11 October 2016

**Re: Addendum: Archaeological Impact Statement, North Plot and The Square
(SSD 7021 and SSD 5878 MOD 2), Darling Square, Darling Harbour Live**

Figure 1: Overlay of impacts (see key) within the North Plot and The Square study area (outlined in orange) onto c.1844 base plan. There are likely to be impacts from six services that may impact the State significant dam wall. Base plan Knapp 1844.

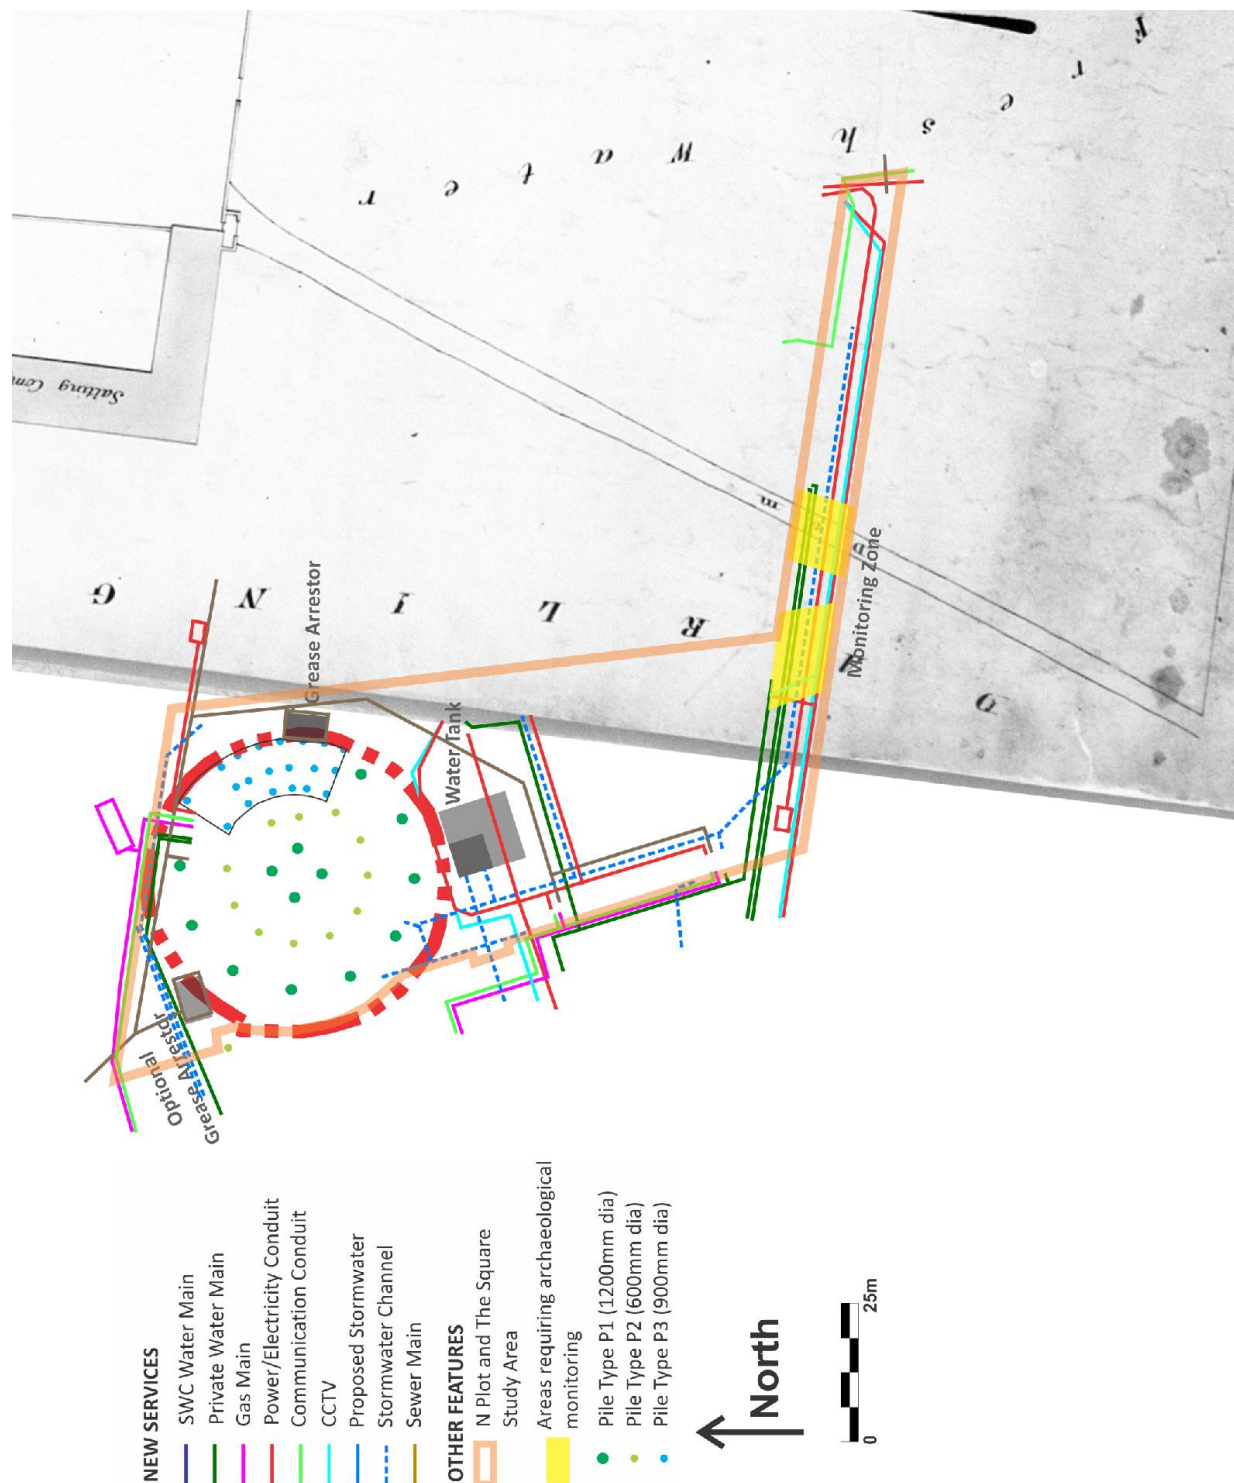
Casey & Lowe have assessed these issues and this amendment has no additional impacts on the State significant archaeology of the c.1815 Dam Wall. The current and proposed impacts are limited to crossing the dam wall by services within the line of the new laneway (Figure 1). This was expected as part of the original proposal and will be resolved at detail design stage. These services impacts will be refined at detail design stage and outlined in detail in the *Historical Archaeological Research Design & Management Strategy* (HARD&MS) to be written for the site. The assessment and recommendations for the services impacts are:

- Impacts are minor, mitigation in the form of monitoring, with a shift to localised salvage excavation if remains are encountered; use of geotextile and clean bedding material is required where the services cross the dam wall (approximately 10m).

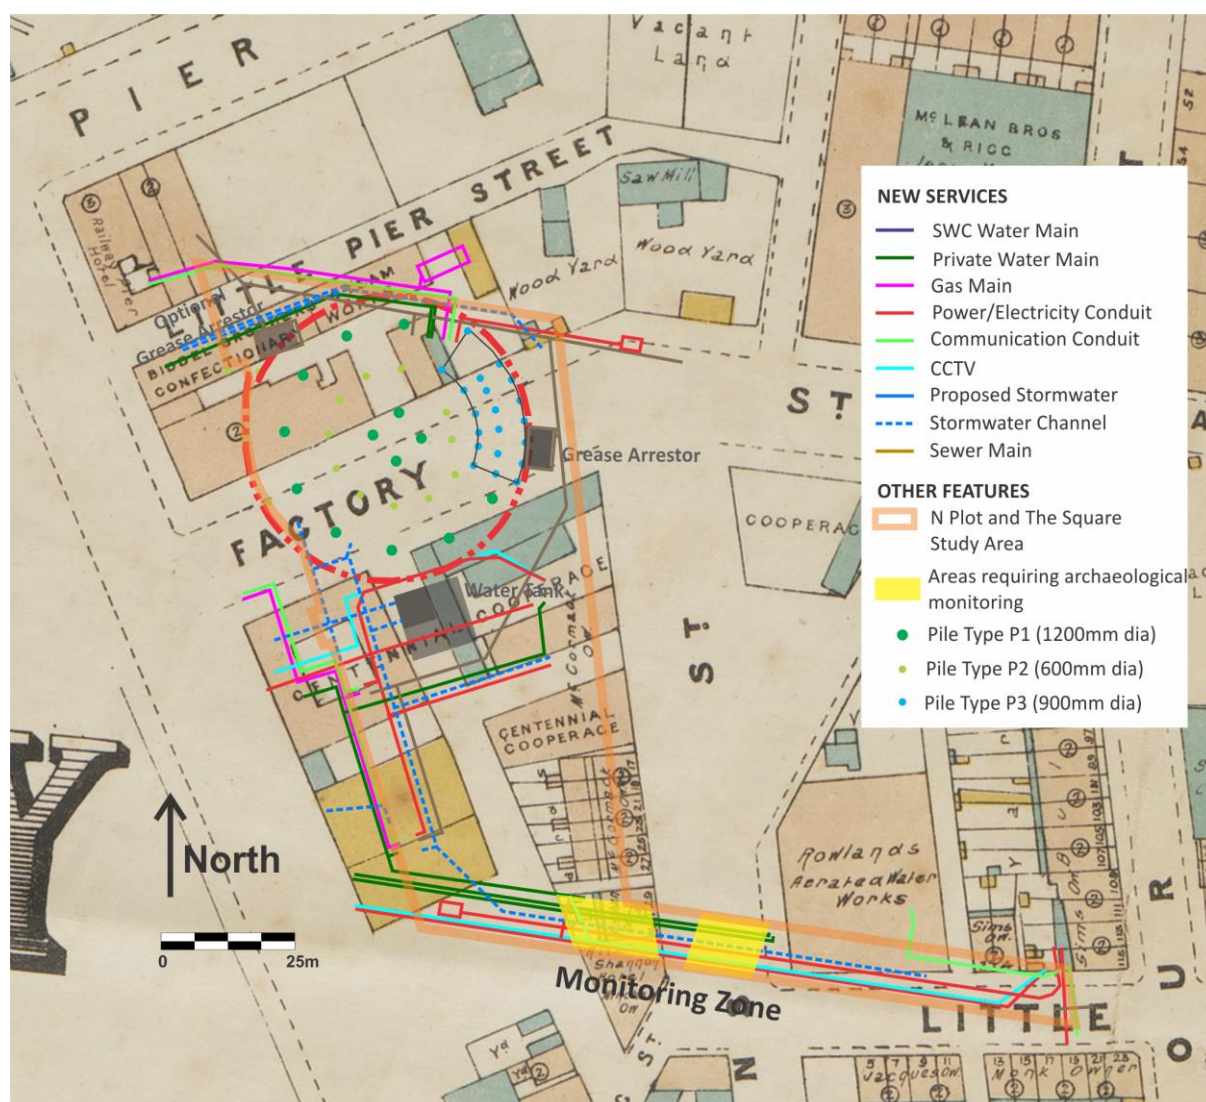
The amended design does not change the general quantum of impacts on locally significant archaeology as outlined in the Archaeological Impact Statement for the site. Figures 2 and 3

show there are some minor changes which are in general agreement with the current proposal. These services impacts will be refined at detail design stage and outlined in the *Historical Archaeological Research Design & Management Strategy* (HARD&MS) to be written for the site. The assessment and recommendations for the services impacts are:

- Impacts are moderate, however, survival of archaeology is uncertain due to more substantial impacts on archaeology found during the Boulevard and North East Plot archaeological programs. The footings of the Sydney Entertainment Centre (SEC) have been more substantial than previously assessed and have had a larger impact. Proposed mitigation through monitoring with a possible shift to salvage excavation if intact cesspit deposits that reach the threshold for local significance are encountered. Monitoring/salvage is also required where the services cross through two houses and yards, and the River Shannon Hotel (approximately 12.5m).
